RE: DRAINAGE REPORT FOR FOUR HILLS WEST, UNIT ONE SUBMITTED FOR PRELIMINARY PLAT APPROVAL (M-22/D9)

Re: Four Hills West Unit One - Drainage Report

RE: DRAINAGE REPORT FOR FOUR HILLS WEST, UNIT ONE - RECEIVED MAY 26, 1987 FOR PRELIMINARY PLAT APPROVAL M22/09

DRAINAGE ANALYSIS for Four Hills West - Unit One May 1987

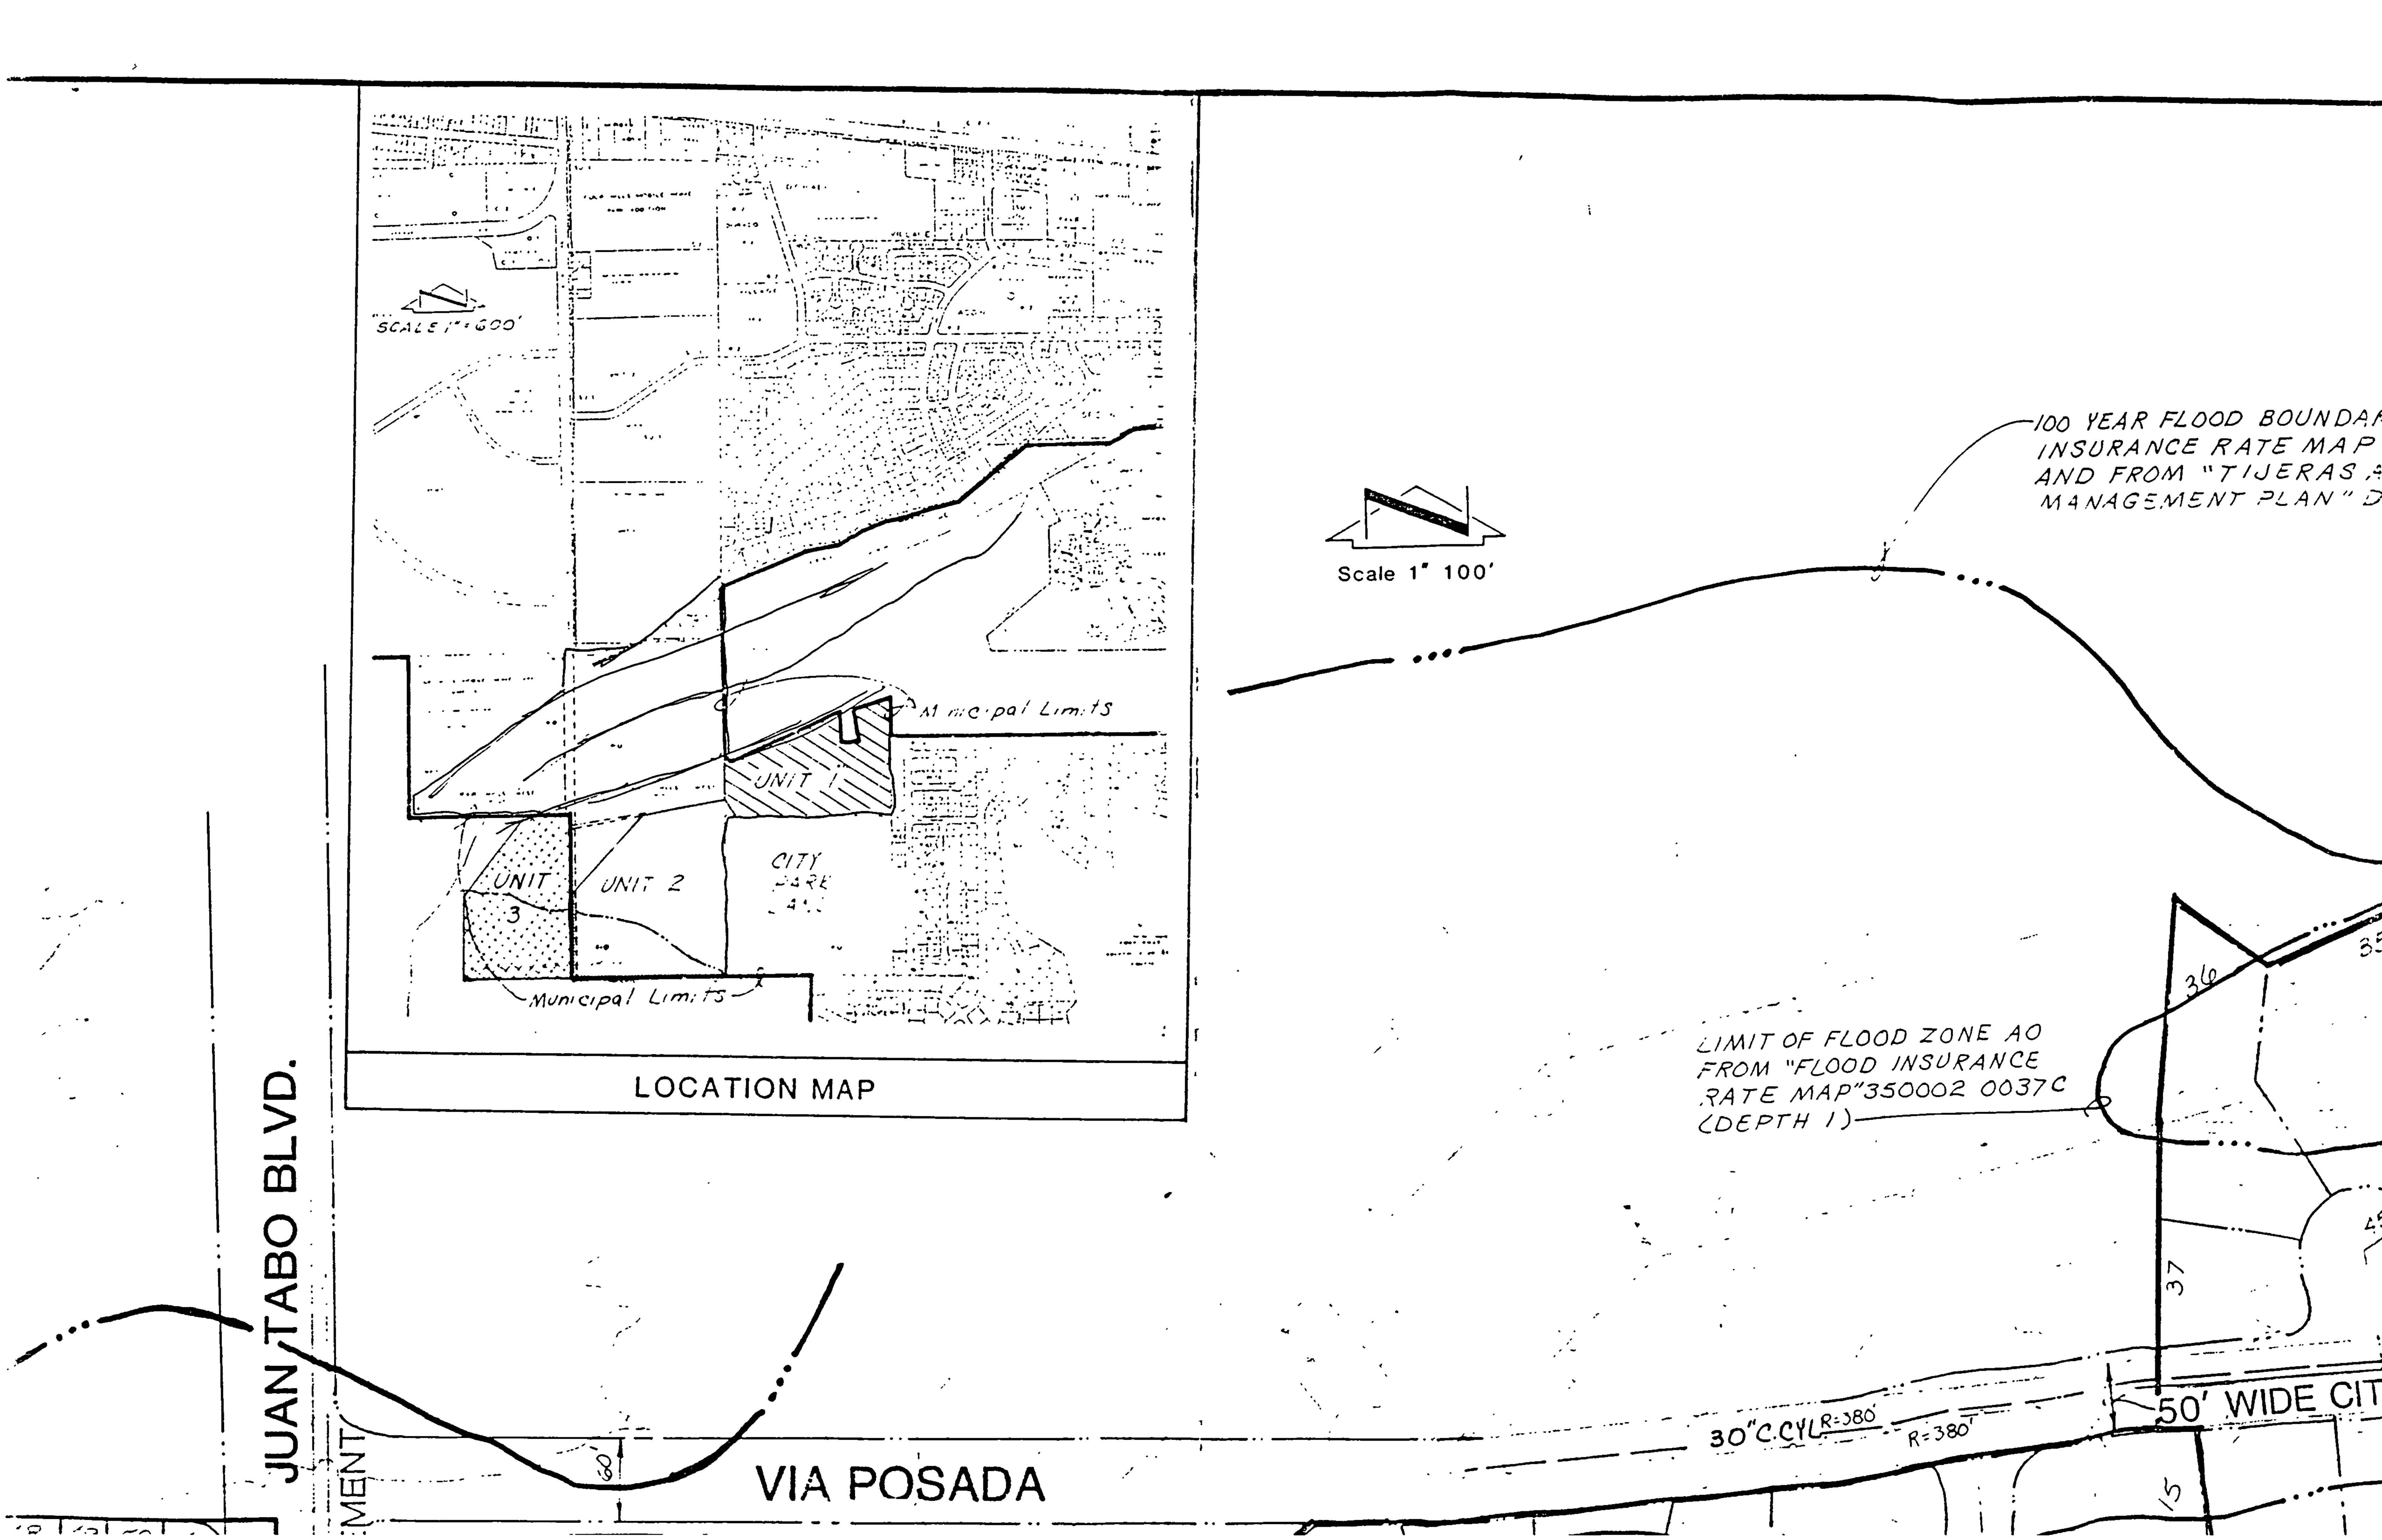
For DRC approval by Hydrology, you will need to submit a final storm sewer design with profile, hydraulic grade line and HGL calculations, and the detail design of the energy dissipator at the outlet.

- C. The analysis shows that the estimated capacity of Via Posada can handle the expected 100 year surface discharge across UNIT ONE. A temporary energy dissipator should be provided at the downstream point of discharge from both surface and subsurface runoff, as shown in Figure 3, prior to release to the Tijeras Arroyo.

- 15,16. Please refer to Figure 3 for the location and configuration of a temporary energy dissipator just downstream of Unit One. This is intended to be a similar installation to the existing facility at the east boundary of UNIT ONE for runoff from VISTA FOUR HILLS and upland areas. When the next Unit is developed, the west of UNIT ONE, the 30" storm drain will be extended through to the Tijeras Arroyo via a future configuration.
